Customer: Leyland
Location: 1-16 The Grange

Date: 06 May 2020

Fire Door Survey

Door ID	7
Surveyor/Technician	Lee Challenger
Building Name	1-16 The Grange
Level	Ground

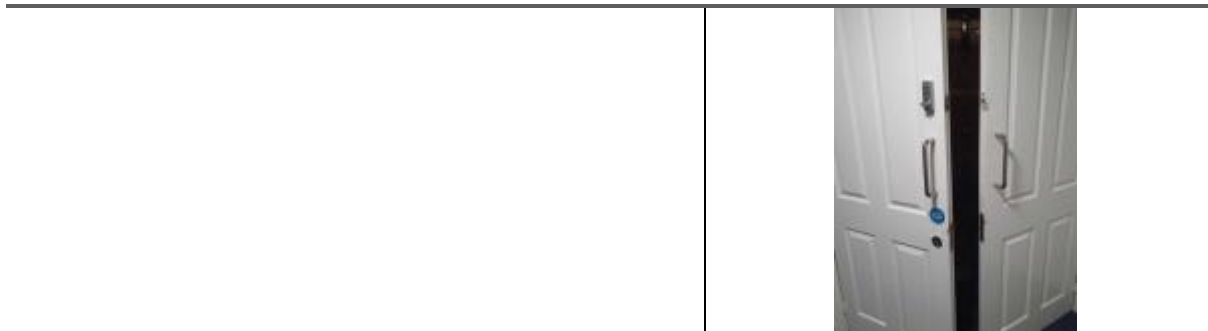
Is the leaf condition of a good standard?	No
Details	Replace
Comments	REPLACE BOTH DOOR LEAFS ,764mm x 1990mm X 2 Doors have been filled with unknown product where old lock was located

Are the seals of a good standard?	No
Details	Replace

Comments	Replace 3 x 10mm fire with 10mm white fire and smoke seals. Fit 15mm white fire and smoke seal to meeting edge of new doors
----------	---

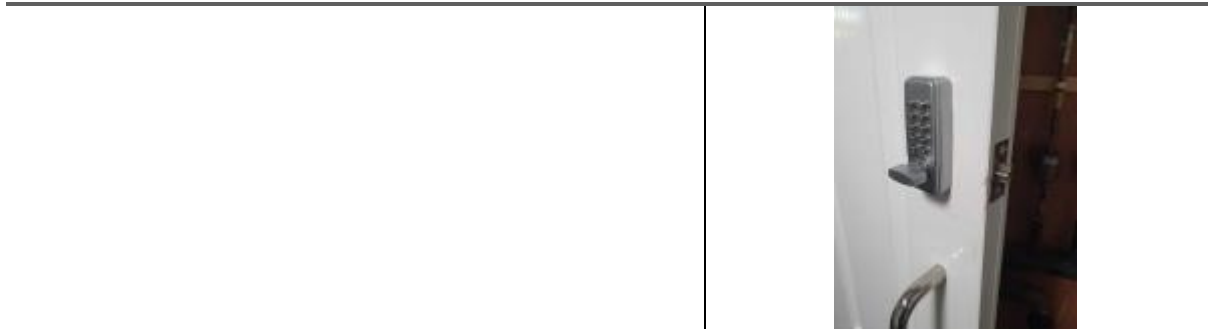
Are the handles/pushes/pulls of a good standard?	No
Details	D-Handle required
Comments	New push plate required

Is the lock/latch of a good standard?	No
Details	Replace
Comments	Replace combination lock with tested product

GENERAL FINDINGS
Comments Signs fitted at wrong height. Fit new signs at correct height. DO NOT REFIT MORTICE LOCK TO NEW DOOR, replace combination lock with tested product
